Issues with the Most Recent Shipment from WSU → Yale
Arrived 3-Jan-2018
5 GEM4

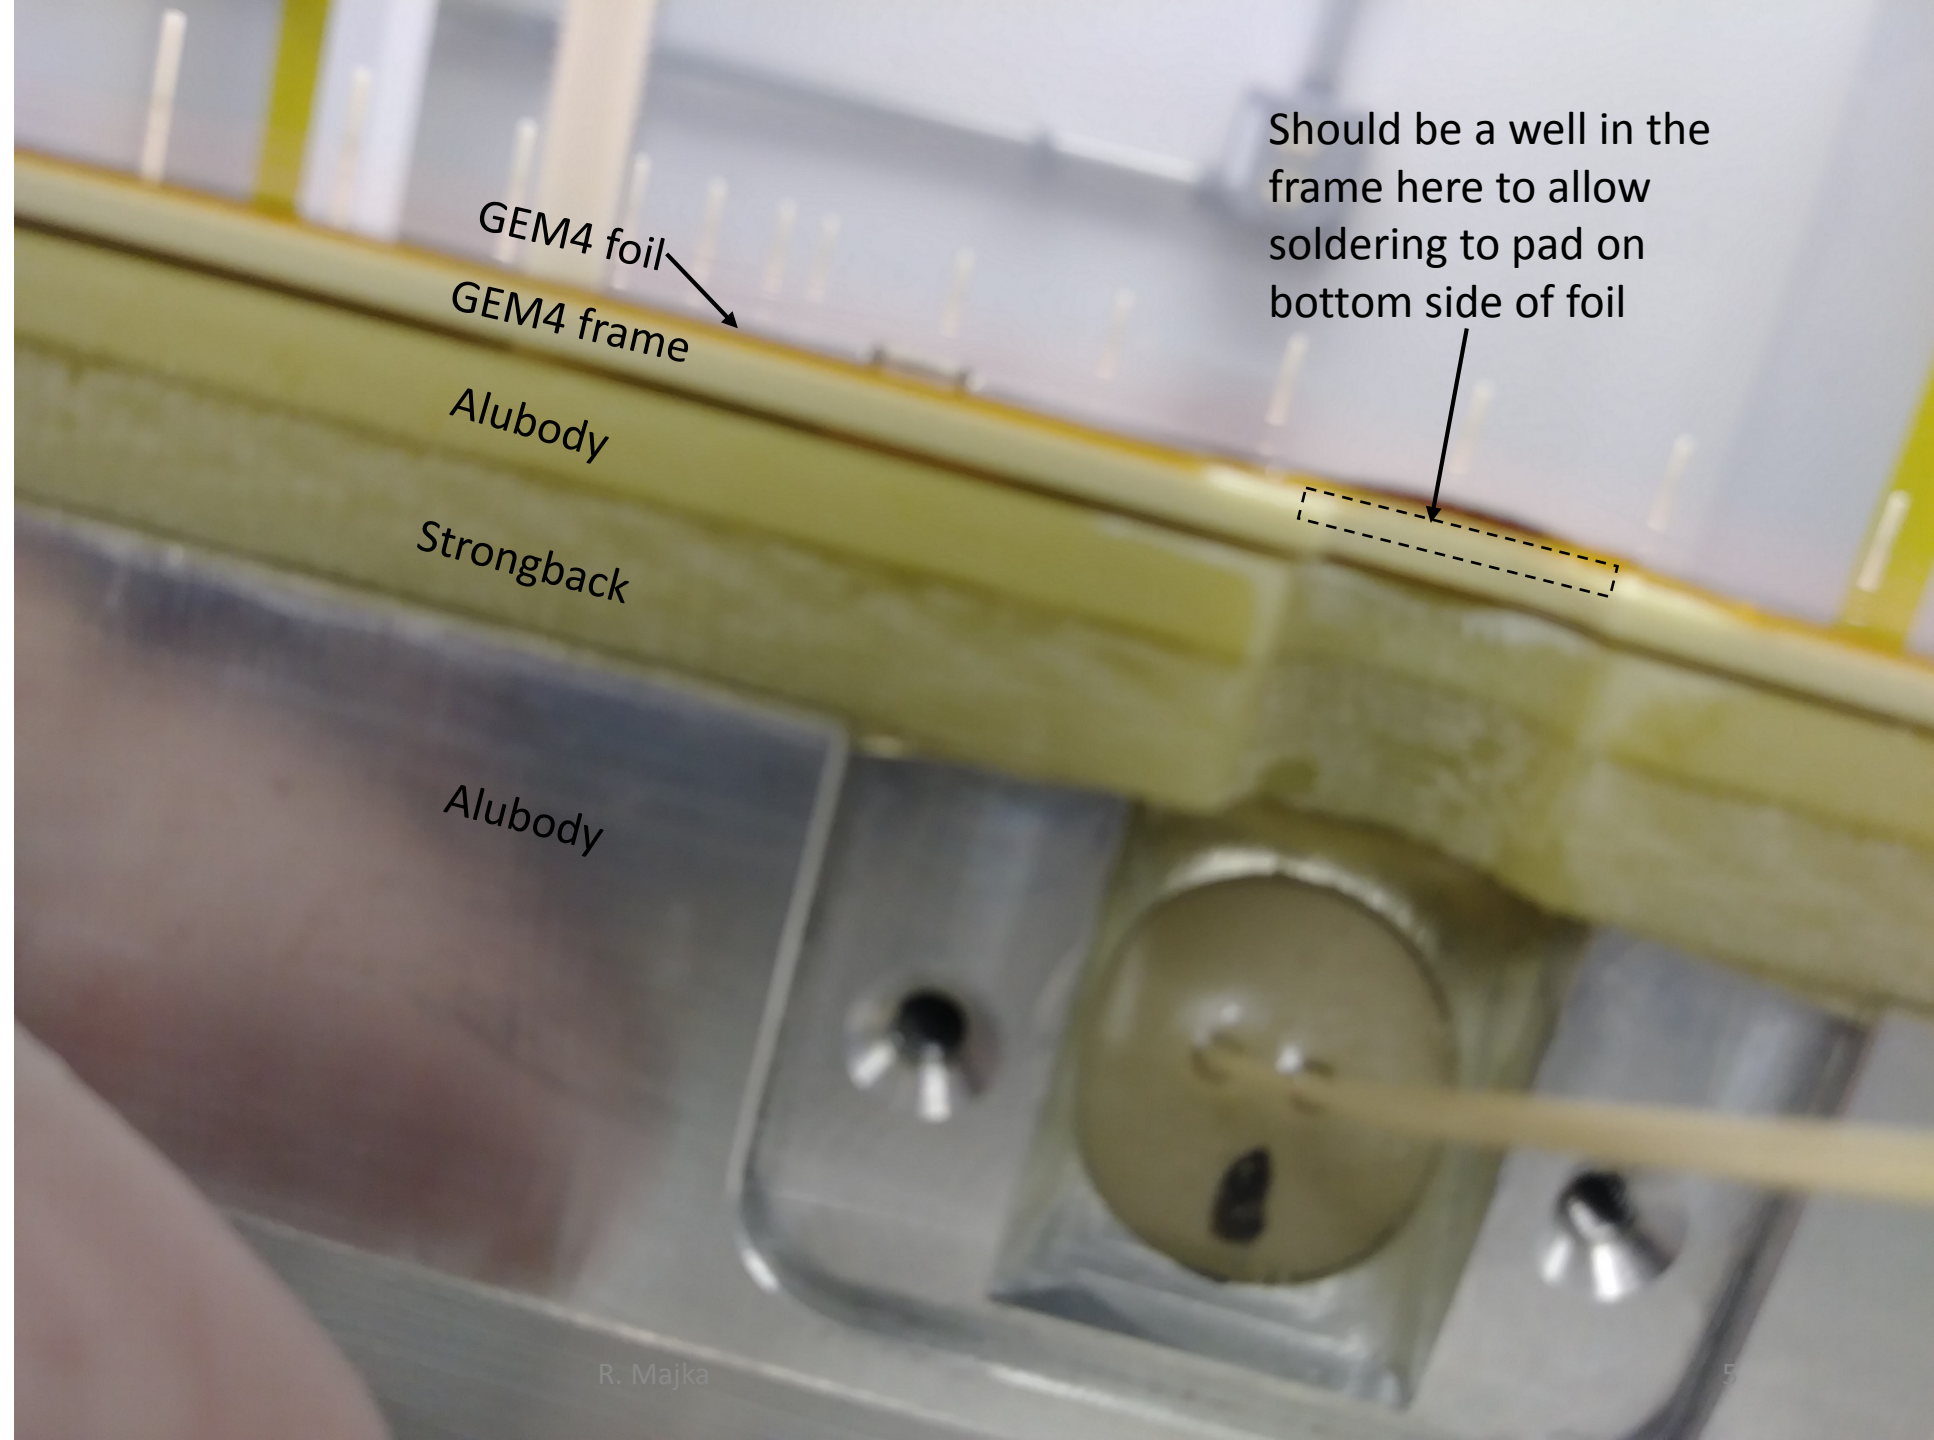
O-ring under GTS cover was not in groove at one end, broken and crushed in two places.
Fortunately contents were still clean.

I-G4-019 – frame not machined properly. The wells for soldering to the bottom HV pads are missing.

I-G4-020 – frame us machined properly.
The wells for soldering to the bottom HV
pads are present.
